# Textown Limited (New Building)

Dewan Idris road, Bara Rangamatia, Ashulia  
(23.9121N, 90.30145E)  
22<sup>th</sup> November 2016

# Observations

## Existence of unstable walkway at east part of the building

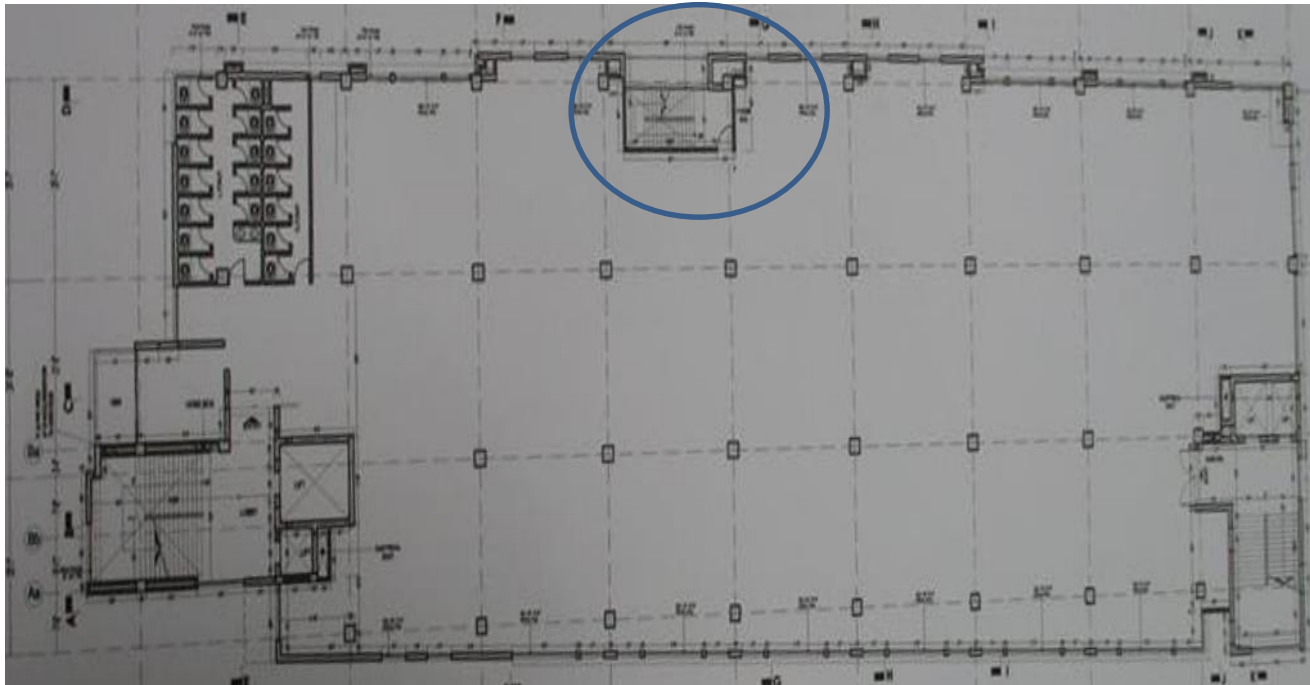
An unstable steel walkway at east part of the building was observed. Building engineer is required to carry out assessment and suggest suitable remedial measure.

**Inconsistency between drawings and on site observation**

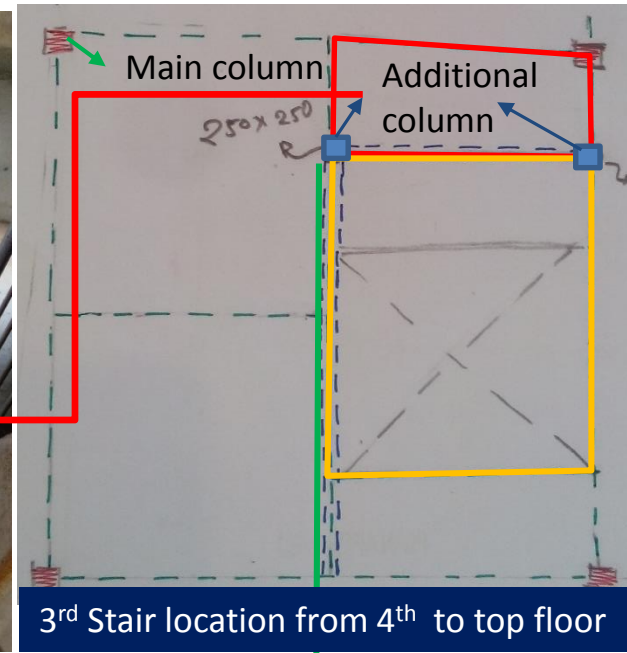
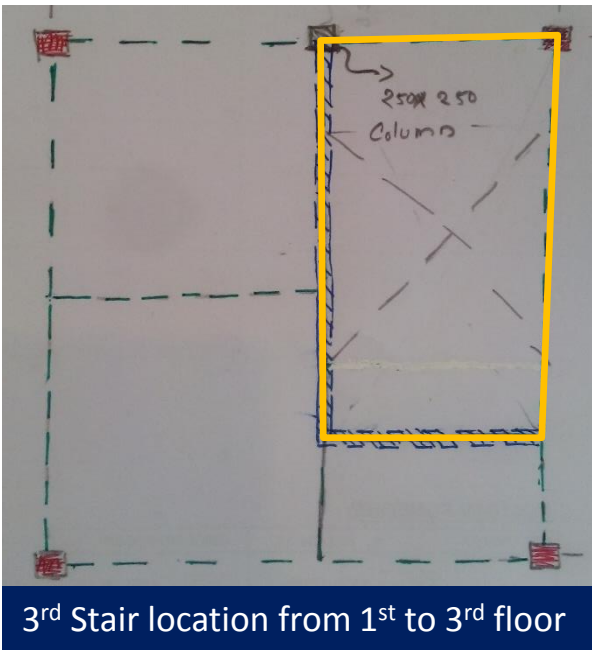
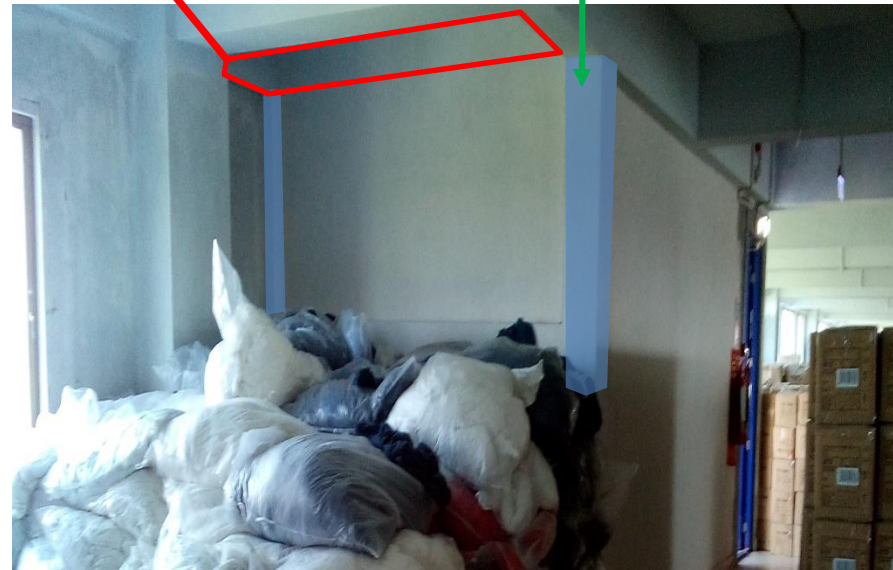
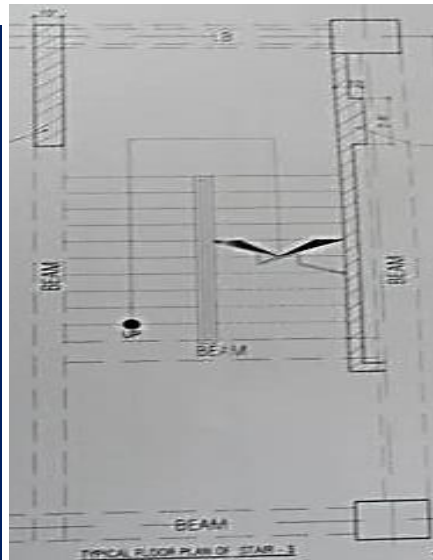
3<sup>rd</sup> stair is sited approximately by 4ft from the location shown in structural drawings and the stair beam is found as supported by 2 additional columns which rested on beams.

Lack of protection on around lift core

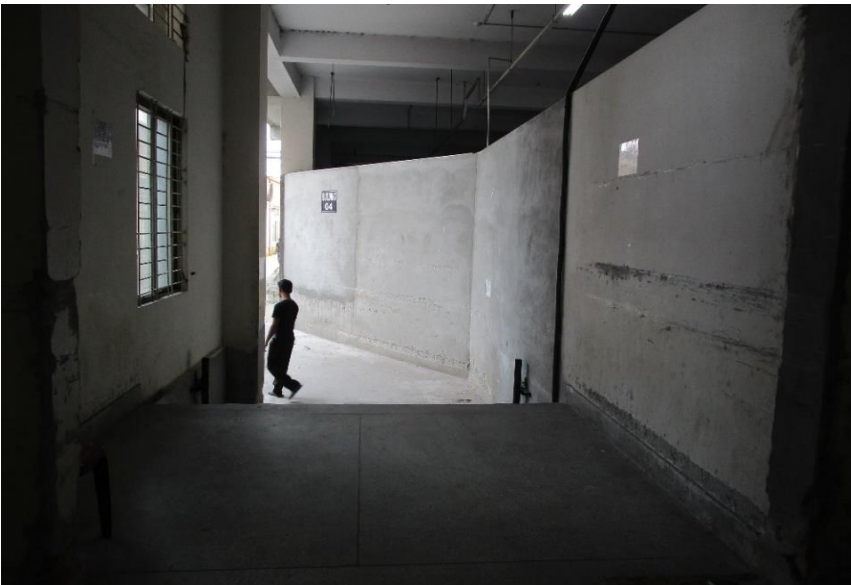
Lack of edge protection around the lift core near stair areas.
